3M Comments for California Energy Commission's Air Filter Labeling Proposal
Docket # 14-AAER-1, Appliance Efficiency Pre-Rulemaking

June 5th, 2014

Figure 1. Clean Filter Pressure Drop of 13 Common Air Filter Models

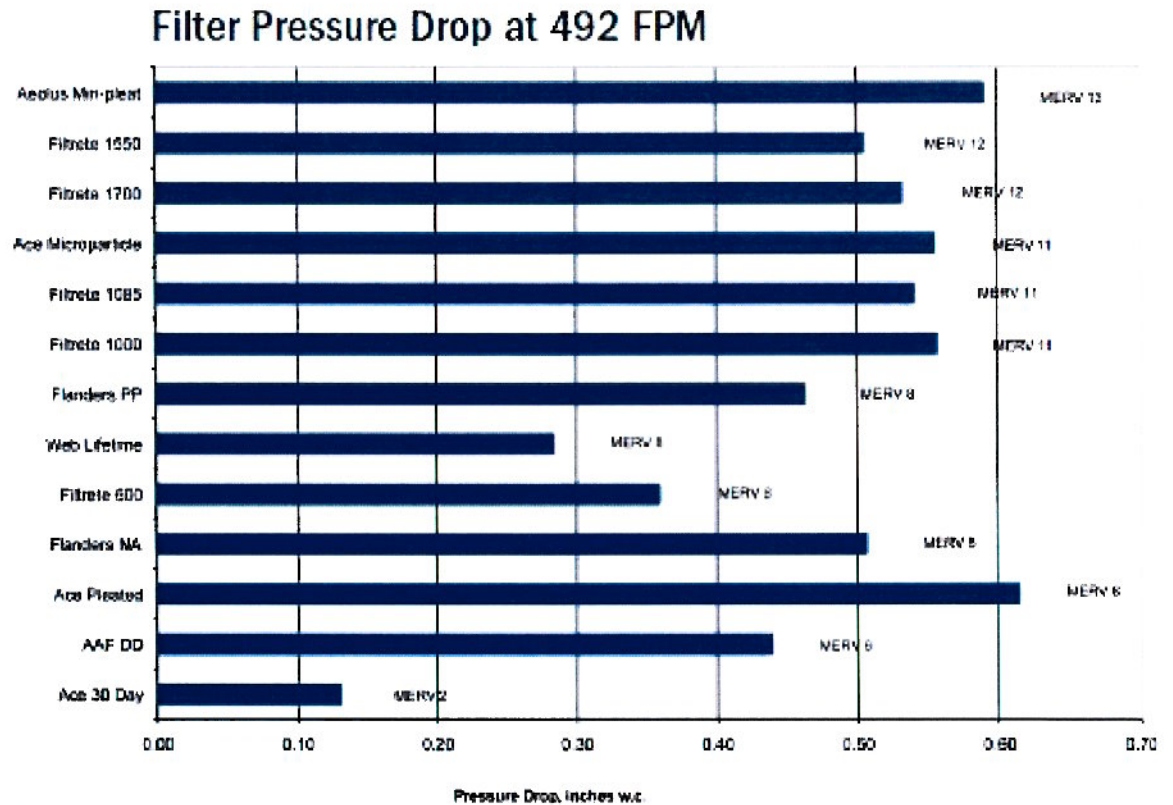
- (1) **The maximum allowable pressure drop should be consistent with actual filter performance.**

As shown by data in "Staff Analysis of HVAC Air Filters, Dimming Fluorescent Ballasts, and Heat Pump Water Chilling Packages" (see Figure 1), none of current MERV 6 or higher filters achieved 0.1 IWC (inches of water column) at 500 FPM, which is ACCA's rule of thumb recommendation for maximum allowable pressure drop. Even at a much lower air velocity, 295 FPM, none of the MERV 6 or higher filters meets the 0.1 IWC or lower recommendation (see Figure 2), according to 3M internal testing of a wide range of common air filter models. Therefore, the maximum allowable pressure drop should be a reasonable value. **0.25 IWC at 295FPM is a reasonable value that most of MERV 6 or higher filters can meet.**
